# Access Compliance Report

## Public Rights-of-Way

### (Curb Ramps)

Intersection ID: 26693	Main Street: CANFIELD_HILL_CT	Cross Street: WINTHROP_RIDGE_RD	Location: SW
ADA ID: 80CDE440D632	Ramp Type: BlendTrans1	Initial Pass/Fail: Fail	Overall Compliance: No
Severity Score: 8.75			
Codes/Mitigation Info/Possible Solution		Field Measurements/Component Compliance

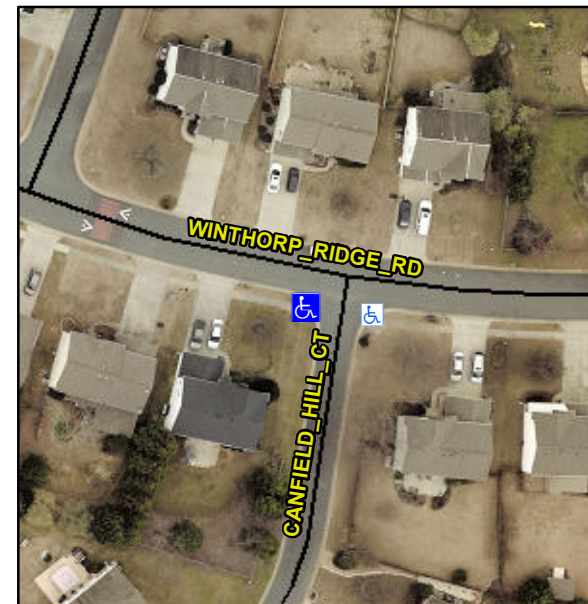
**Not Found, R304.5.1**

Compliance	Description	Data	Compliance	Description	Data
N/A	Ramp Length (in)	57.0	Yes	BlendTrans Slope (%)	3.0
No	Ramp Width (in)	41.0	Yes	BlendTrans XSlope (%)	0.2
N/A	Flare Type LT	N/A	N/A	Flare Type RT	N/A
N/A	Flare Slope LT (%)	N/A	N/A	Flare Slope RT (%)	N/A
N/A	Flare Traversable LT?	N/A	N/A	Flare Traversable RT?	N/A
N/A	Landing Length (in)	N/A	N/A	DWS Provided?	N/A
N/A	Landing Width (in)	N/A	N/A	DWS Contrast?	N/A
N/A	Landing Slope (%)	N/A	N/A	DWS Length (in)	N/A
N/A	Landing X Slope (%)	N/A	N/A	DWS Full Width?	N/A
N/A	Landing Curb? (Y/N)	N/A	N/A	DWS Offset (in)	N/A
N/A	Shared Landing?	N/A			
N/A	Gutter Ponding?	N/A	N/A	Gutter Slope (%)	N/A
N/A	Gutter Lip Ht (in)	N/A	N/A	Gutter X Slope (%)	N/A
N/A	Painted X Walk1?	No	N/A	Painted X Walk2?	N/A
	X Walk 1 Direction	To E		X Walk 2 Direction	N/A
	X Walk 1 Width (in)	N/A		X Walk 2 Width (in)	N/A
	X Walk 1 Slope (%)	3.6		X Walk 2 Slope (%)	N/A
	X Walk 1 X Slope (%)	1.1		X Walk 2 X Slope (%)	N/A

N/A	Ramp inside XWalk1?	N/A	N/A	Ramp inside XWalk2?	N/A
	Road Slope (%)	1.1		Clear Space?	N/A
	Road X Slope (%)	3.6	N/A	Clear Space to XWalk (in)	N/A
N/A	Any Obstructions?	N/A	N/A	Storm Grate/Utility Hazard?	N/A
	Obstruction Type			Storm Grate/Utility Type	
		N/A			N/A
			Yes	Surface Condition? (G/P)	Good
			No	Curb Slope (%)	13.9

**Remove & Replace Curb Ramp With Two New Directional Ramps or Equivalent.**
